Pollard Street

Section 73 Addendum to Accompany
Design and Access Statement

December 2023

Hawkins\Brown

South Elevation - proposed

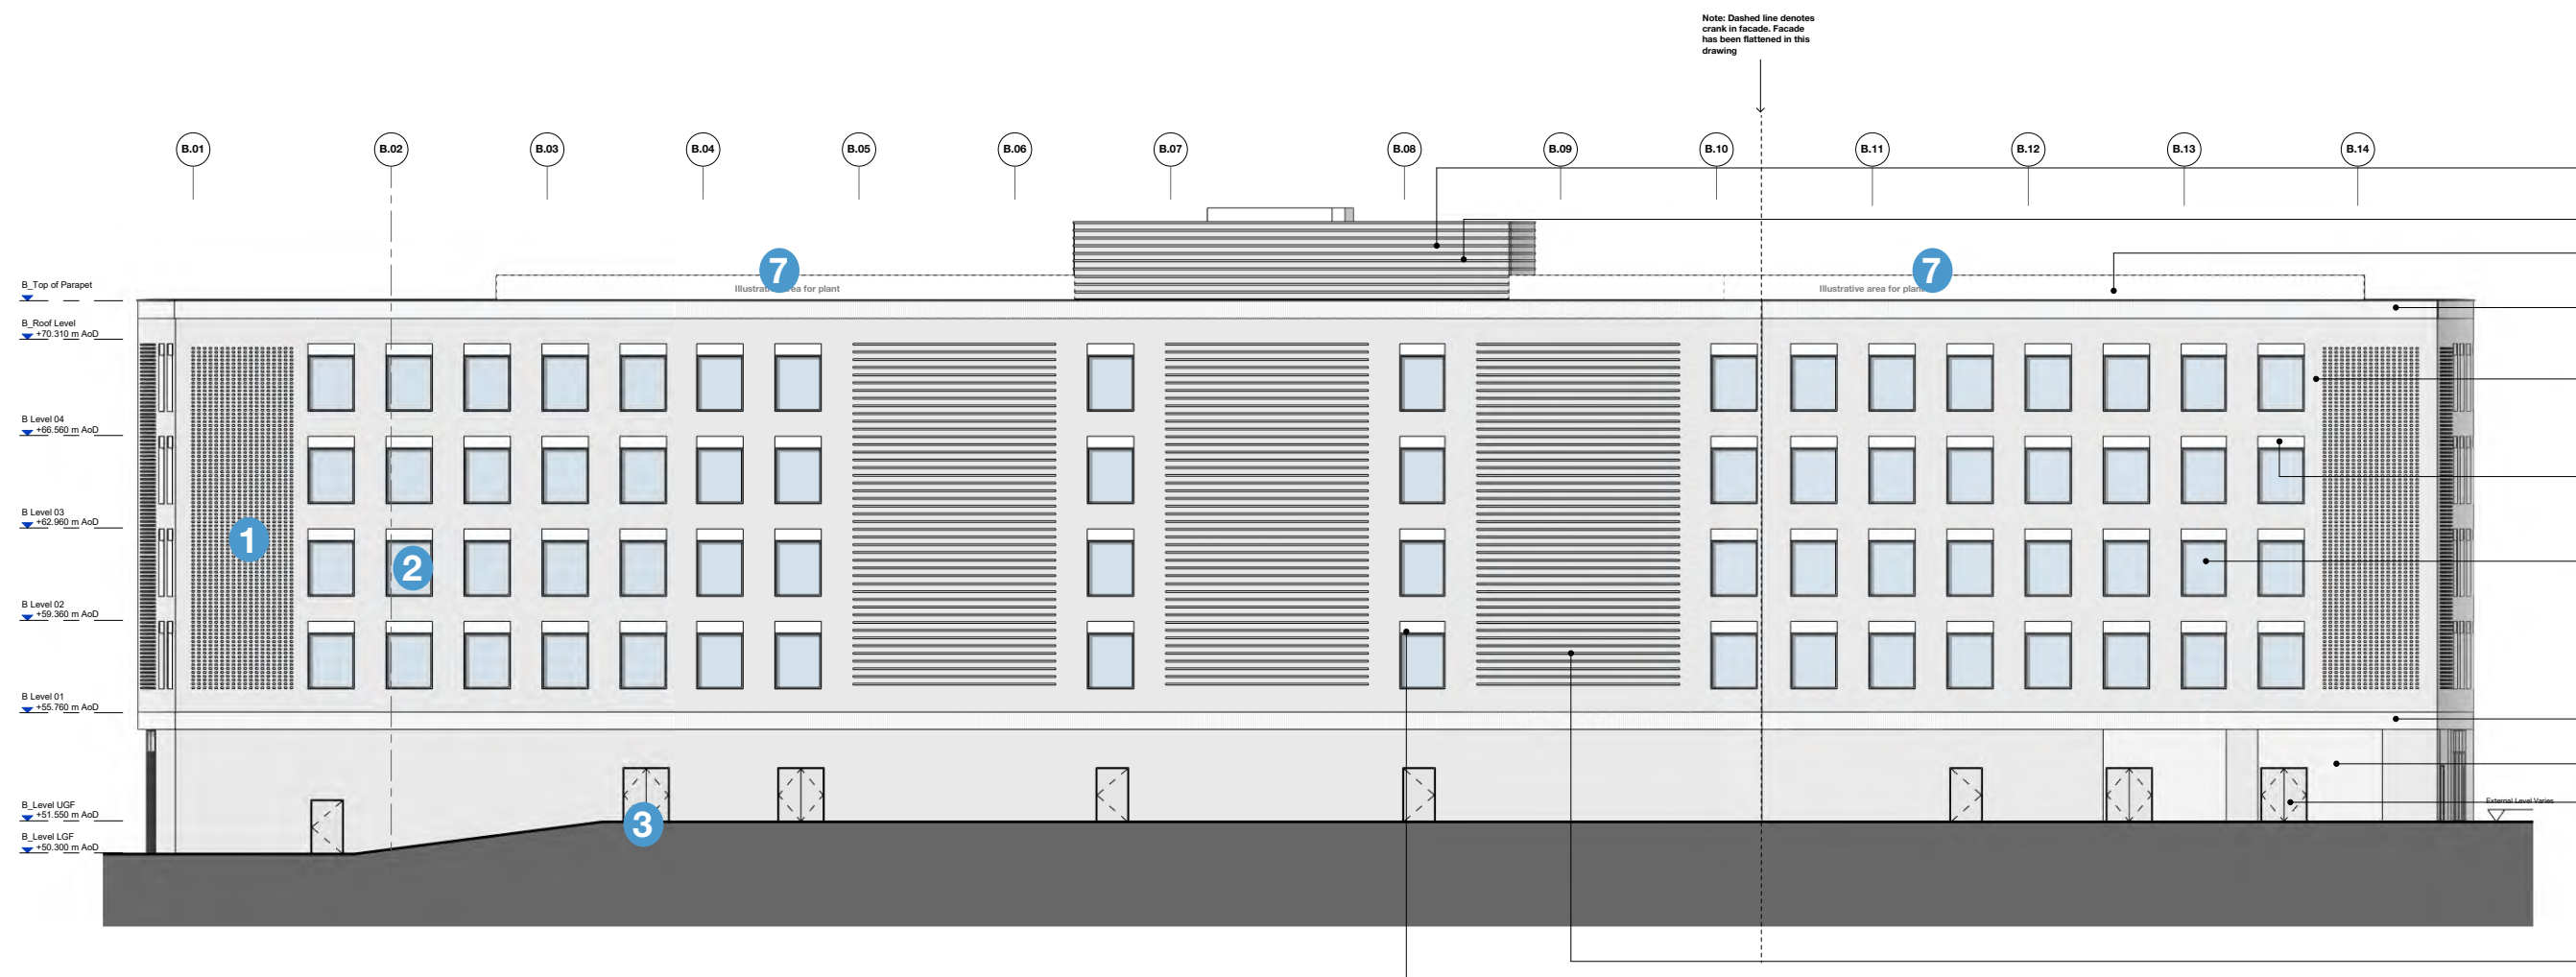
1. Primary façade cladding changed from metalwork to brickwork
2. Window arrangement updated
3. Ground floor access relocated
4. Second stair relocated within the central core
5. Internal layout updated
6. External gantry / access deck omitted
7. Position of plant screen updated
8. Roof access updated

Ground Floor Plan

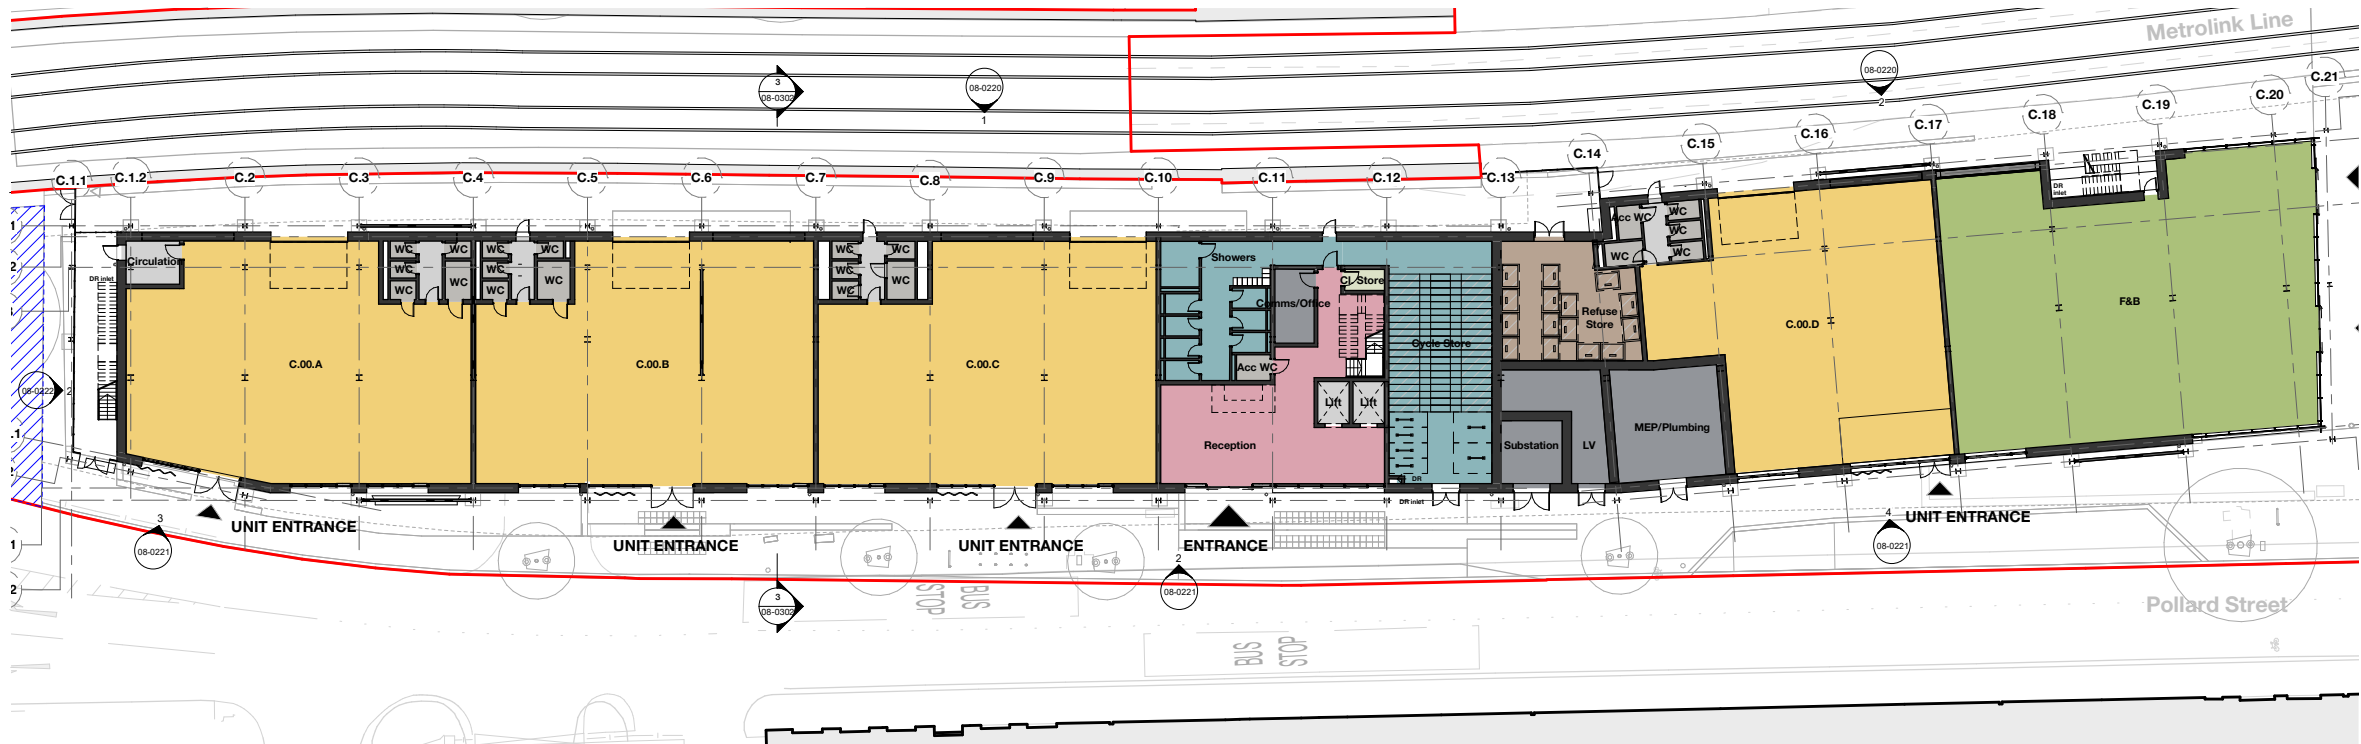
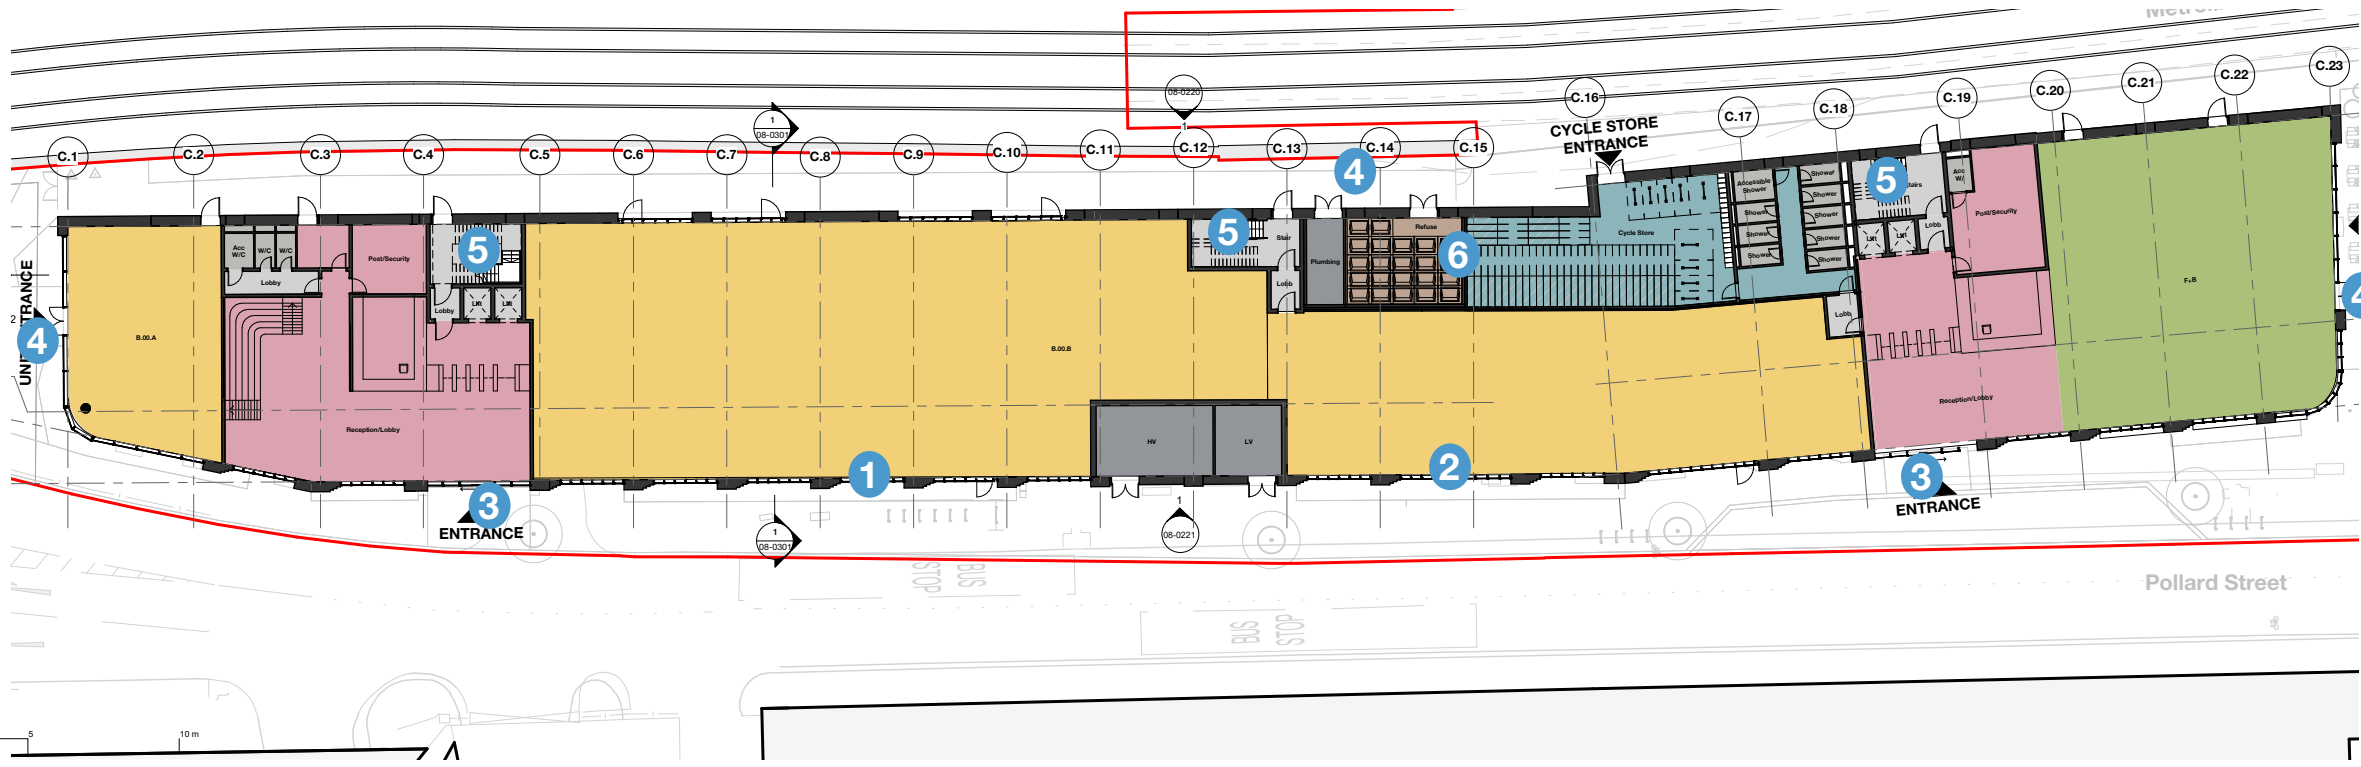
1. Primary façade cladding changed from metalwork to brickwork
2. Window arrangement updated
3. Main workspace entrance relocated
4. Ground floor access relocated
5. Core / circulation strategy updated
6. Internal layout updated
7. External gantry / access deck omitted
8. Position of plant screen updated
9. Roof access updated

First Floor Plan

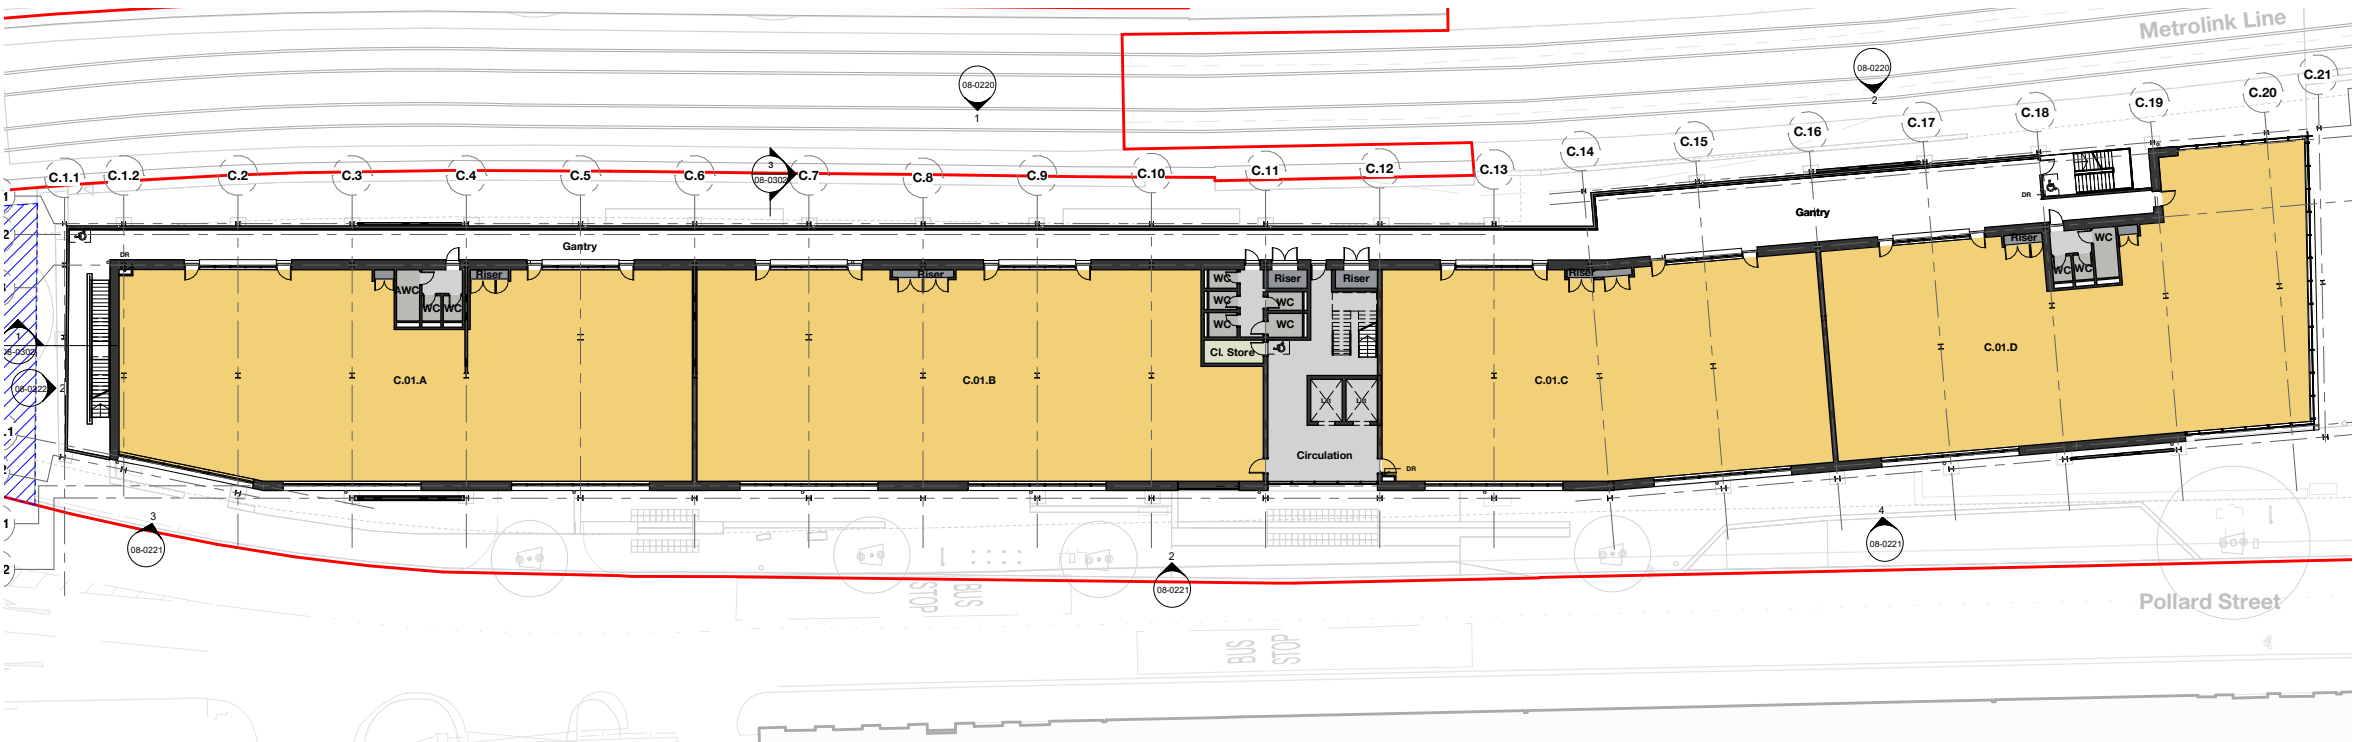
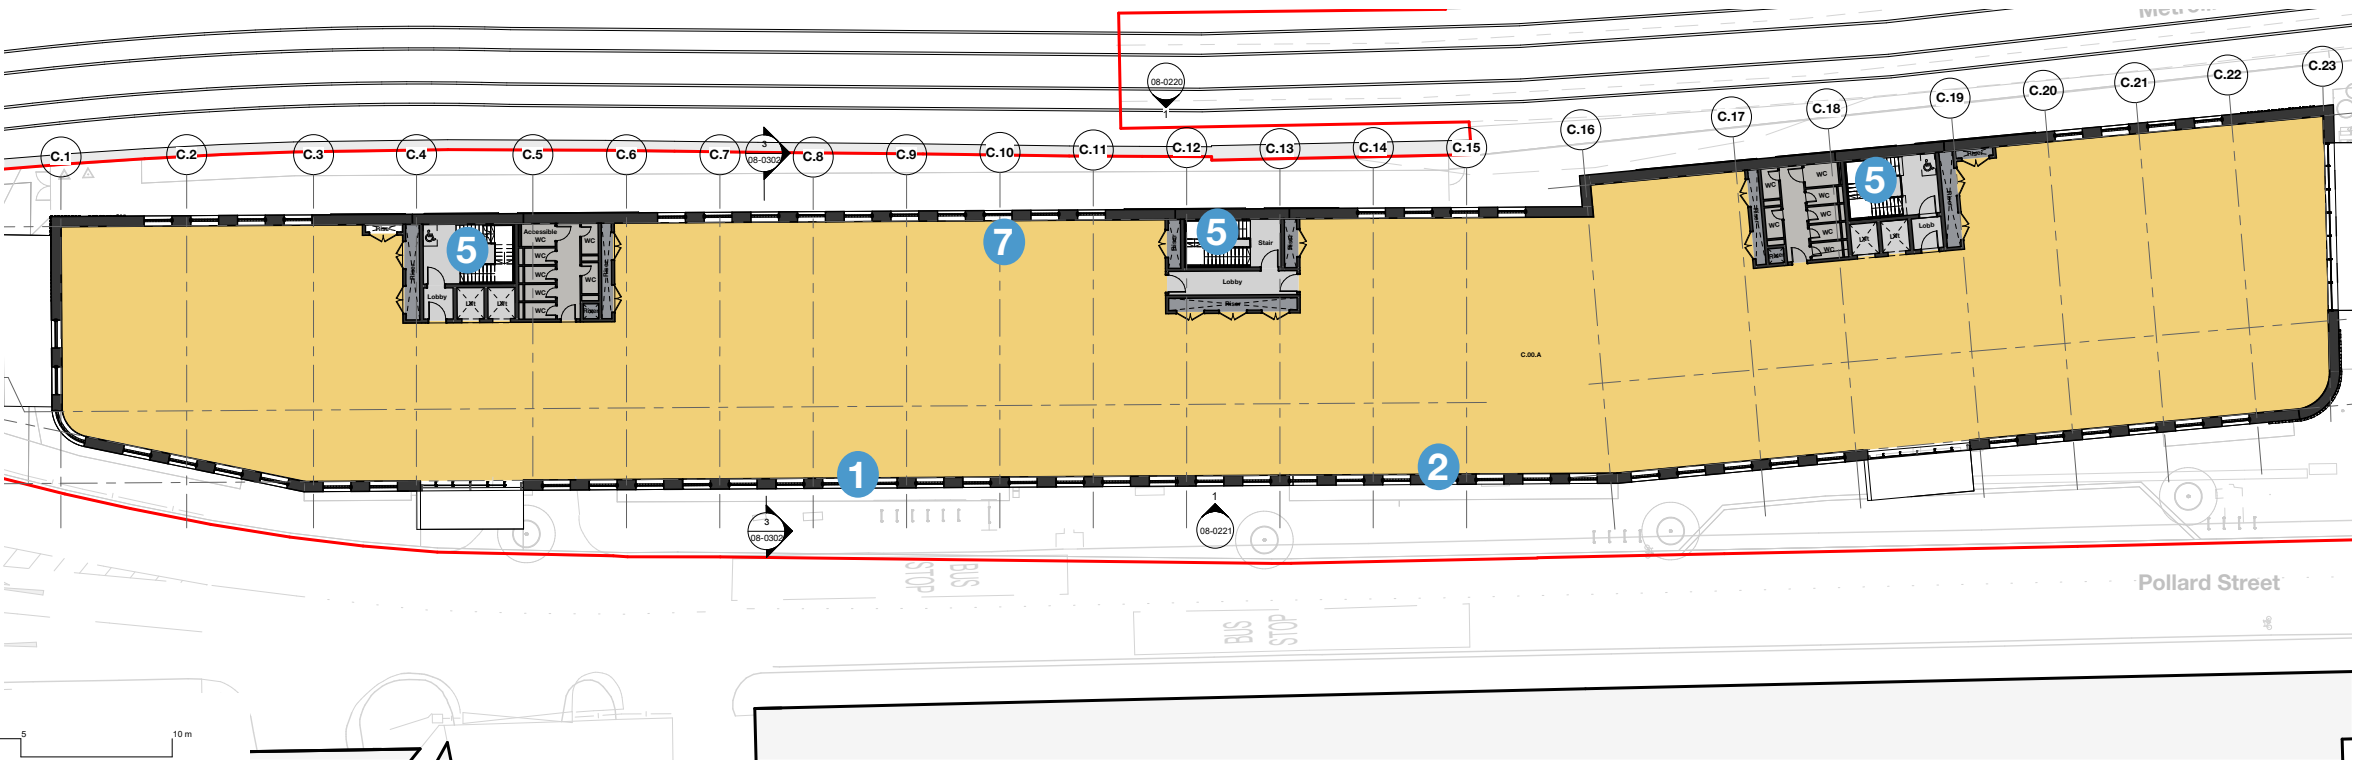
1. Primary façade cladding changed from metalwork to brickwork
2. Window arrangement updated
3. Main workspace entrance relocated
4. Ground floor access relocated
5. Core / circulation strategy updated
6. Internal layout updated
7. External gantry / access deck omitted
8. Position of plant screen updated
9. Roof access updated
